**Subject: Response to Commission's Additional Information Request  
Shawmut Hydroelectric Project (FERC No. 2322)**

**Shawmut Project Relicensing (FERC No. 2322)**  
**Attachment 1 – Response to Deficiencies in Schedule 1**

**Shawmut Project Relicensing (FERC No. 2322)**  
**Attachment 2 – Response to Additional Information Requests (AIRs)**

**Photo 1. Shawmut Project Sluice Gate (near, boxed) and Tainter Gate (far) Plunge Pools.**

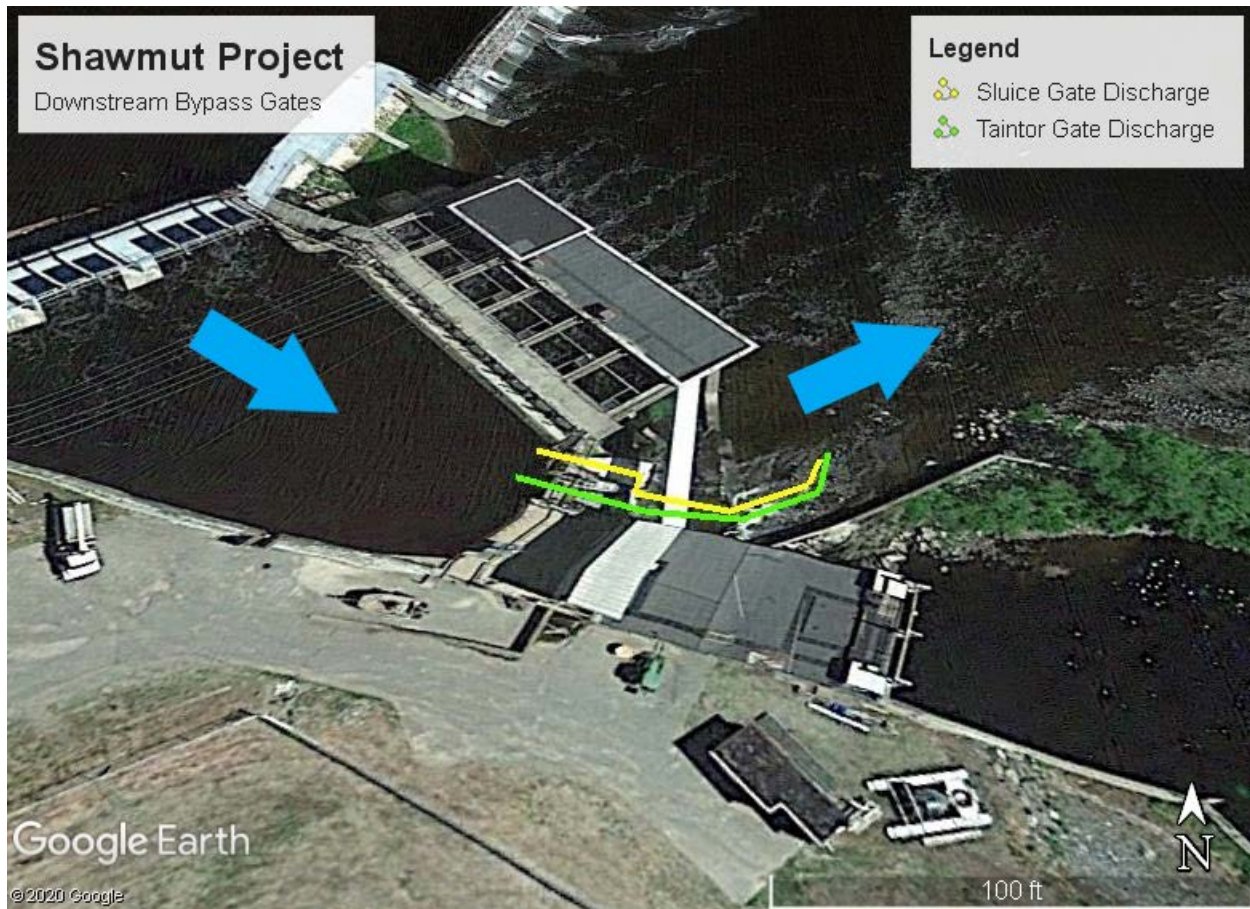
8. *On page E-4-70, you indicate that the forebay surface sluice passes water over the face of the dam into a 3-foot-deep plunge pool connected to the river. You also indicate that the Tainter gate is located next to the sluice. However, you provide no additional information about the plunge pool. We will need to assess the effects of the plunge pool on downstream migrating fish. Therefore, please describe the dimensions and physical characteristics of the plunge pool (e.g., any physical structures or modifications to the stream channel that were constructed to create the plunge pool). Please also provide the drop height between the invert elevation of the sluice and the water surface elevation of the plunge pool. Further, please indicate whether, under existing conditions, the Tainter gate or any other forebay gates also discharge to the plunge pool (and if not then specify where they currently discharge to), and whether any of the three forebay facilities (e.g., surface sluice, Tainter gate, deep gate) would discharge to the existing plunge pool or to another location after construction of the new fish passage facilities shown on your January 7, 2020 final fish passage facility design drawings. Lastly, please provide the following information with respect to the new downstream fish passage flume shown on your final design drawings: (i) identify which of the three forebay facilities (i.e., surface sluice, Tainter gate, deep gate) would discharge through the new downstream flume into the Units 7&8 Tailrace, (ii) provide the drop height from the invert elevation of any such facilities to the water surface elevation of the tailrace, and (iii) explain whether you would construct an additional plunge pool in the Unit 7&8 Tailrace to facilitate safe passage of downstream migrants passing through the new downstream passage flume.*

The Tainter gate is located between the old and new powerhouses. The Tainter gate measures 7 ft high by 10 ft wide and can pass up to 600 cfs. Under existing conditions, the Tainter gate discharges into the river channel on the Unit 1-6 powerhouse side of the island. The plunge pool area of the discharge zone is about 4 feet deep, 10 ft wide and 8 ft long. The deep gate that is used for American eel passage and which is positioned below the Tainter gate, discharges into this same plunge pool. The stop log sluice located to left of the Tainter gate (looking downstream) discharges into a boxed plunge pool which is 3 feet deep and approximately 10 ft by 10 ft in dimension. Photo 1 provides a view of the sluice gate and Tainter gate plunge pools. Figure 1 illustrate the current location and direction of flow from both the sluice gate and Tainter gate. The invert elevation of the Tainter gate is 105'. The normal tailwater elevation is approximately 88.0'. The invert elevation of the sluice gate, with all stop logs removed is 111 ft.

The proposed upstream fishway construction will result in changes into the discharge location and route from the Tainter gate and deep gate. The sluice gate will continue to discharge to the Unit 1-6 tailwater area essentially as it does now. Discharge from the Tainter gate and deep gate will be routed through a new concrete flume which will discharge to the Unit 7&8 tailwater area. Figure 1, shows the discharge route directions once the new fishway and flumes are constructed. Since under this new configuration water from the Taintor gate will flow down a concrete apron into the flume, and since the flume will discharge into the deep (approximately 20 ft deep) Unit 7&8 tailwater area, there will be no need for a plunge pool under the planned configuration.

Figure 2-1 Overview of Shawmut Project Facilities

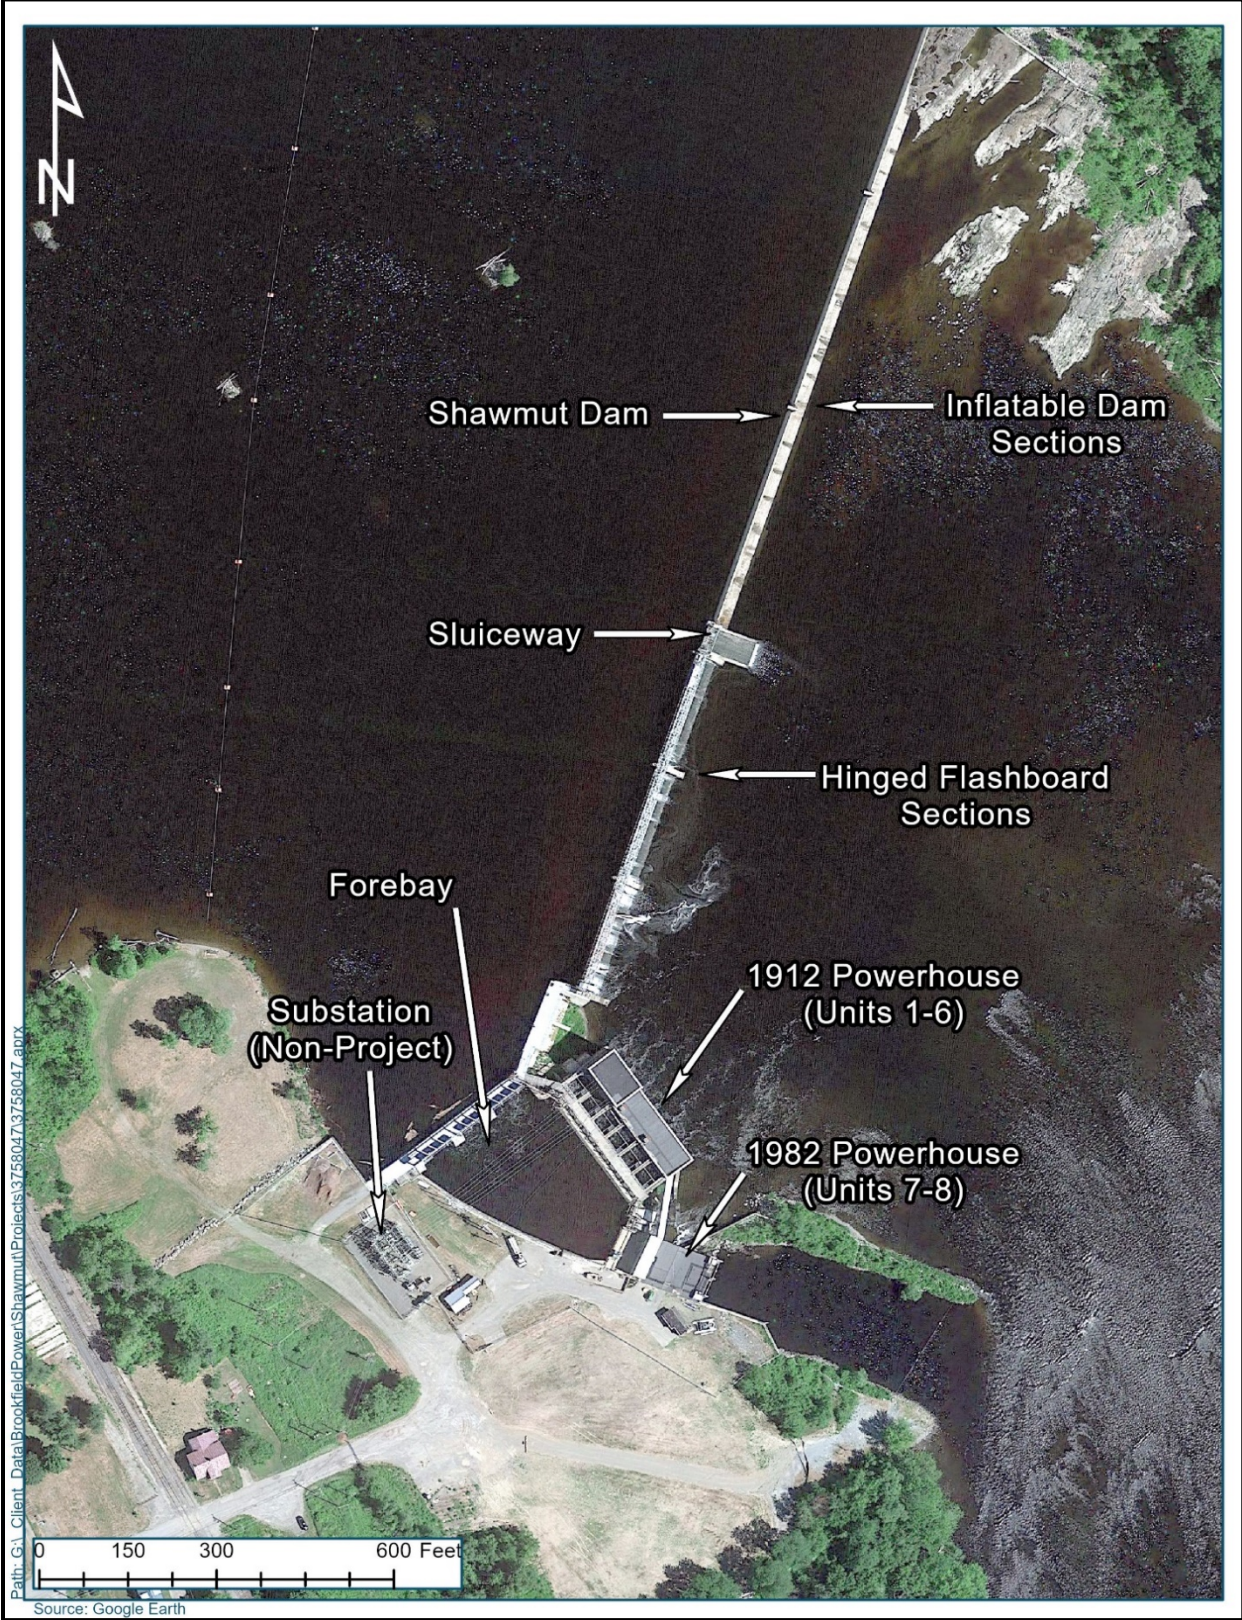
1. *Section 4.51 (b)(1) of the Commission’s regulations requires the physical composition, dimensions, and general configuration of any dams, spillways, penstocks, powerhouse, tailrace, or other structures whether existing or proposed, to be included as part of the project. Exhibit A of your final license application (FLA) did not provide the dimensions of: (i) non-overflow section between the hinged flashboards and the forebay headworks structure, (ii) headworks structure, and (iii) the concrete wall beyond the west abutment of the headworks structure. Please update your Exhibit A to include this information.*

Exhibit A has been updated to include the additional detail requested, to the extent the information is available. The revised Exhibit A is attached as Attachment 3.

DRAWING DESCRIPTION  
**Fish Guidance System**

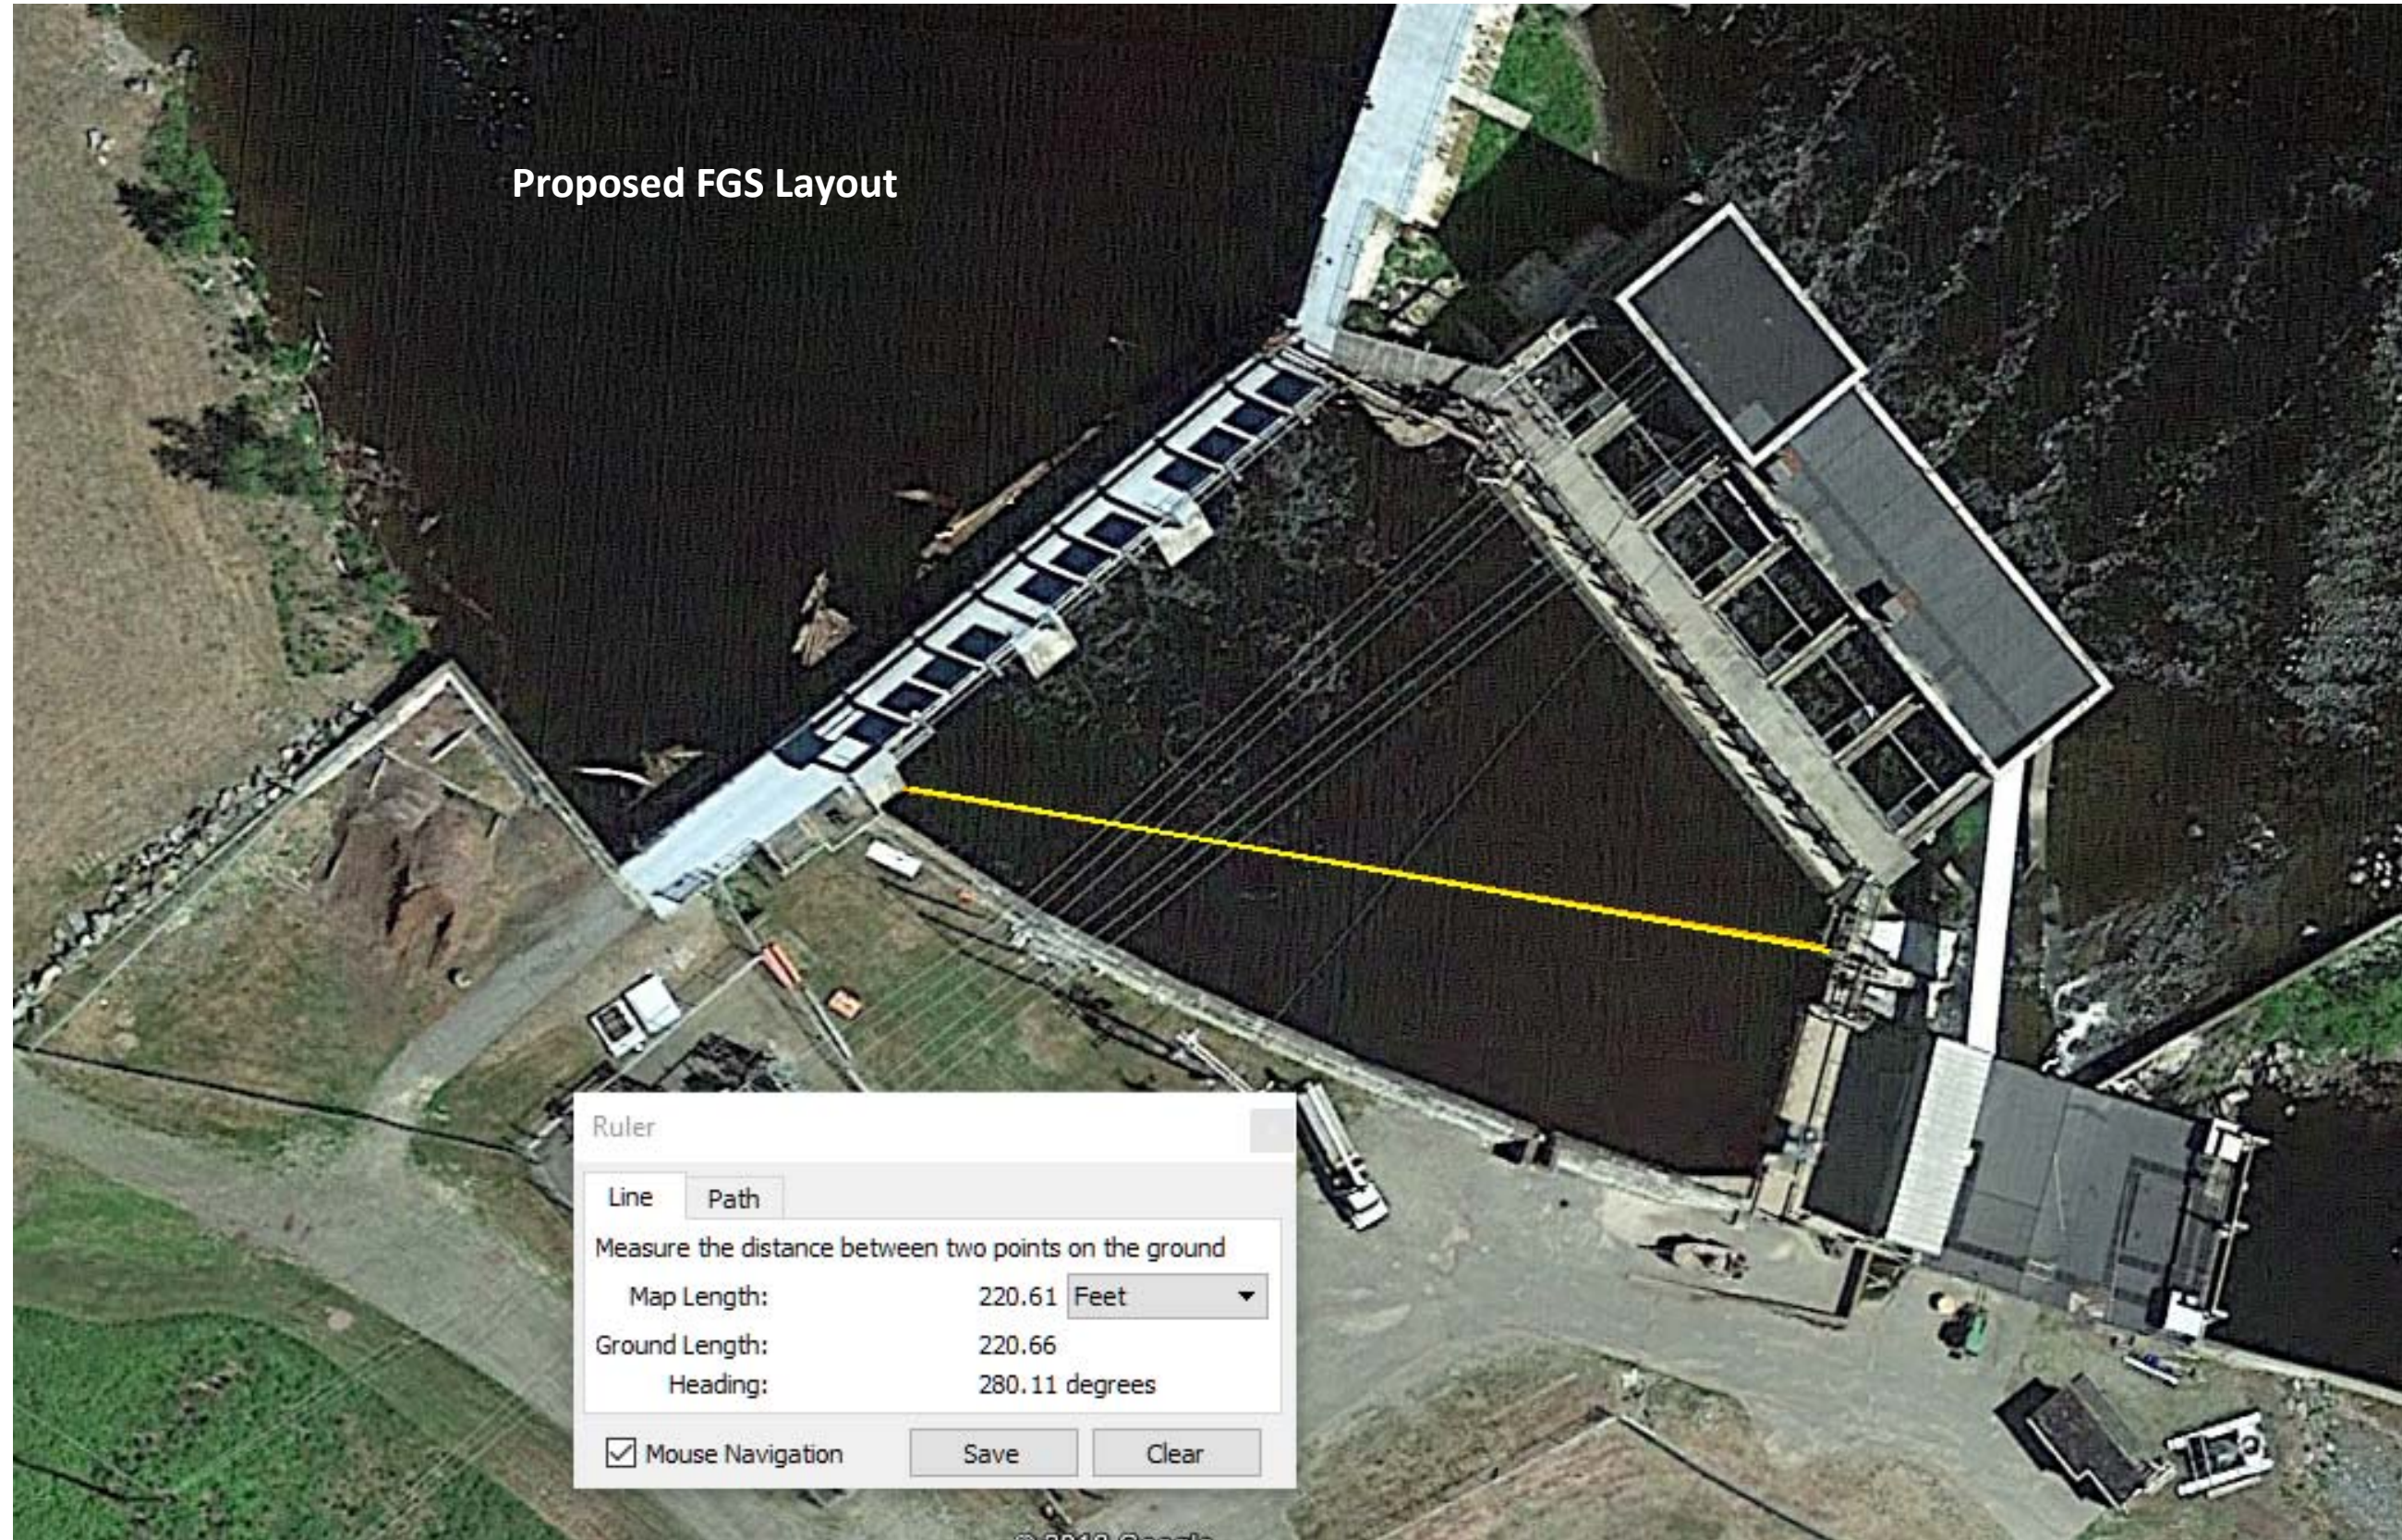
4. *Section 5.18(b)(5)(iii)(A) of the Commission’s regulations requires that Exhibit E include functional design drawings of any fish passage and collection facilities or any other facilities necessary for implementation of environmental measures. Section 5.18(b)(iii)(C) requires that Exhibit E include an implementation or construction schedule for any proposed measures or facilities, showing the intervals following issuance of a license when implementation of the measures or construction of the facilities would be commenced and completed. You did not provide design drawings for the proposed forebay guidance boom to bypass Units 7 and 8, nor a construction schedule for this new proposed facility. Please revise your application to include this information. The drawings must conform to the specifications of section 4.39 of the Commission’s regulations regarding dimensions of full-sized prints, scale, and legibility.*

The forebay guidance boom has been proposed as a downstream fish passage enhancement measure as part of the Kennebec SPP and as a PME measures for the Shawmut Project relicensing. As such, installation of the proposed guidance boom is still in the conceptual state, and there are as yet, no detailed design drawings for the proposed boom installation. However, conceptual design plans, developed by the guidance boom manufacturer, Worthington Boom, are provided in Attachment 4.
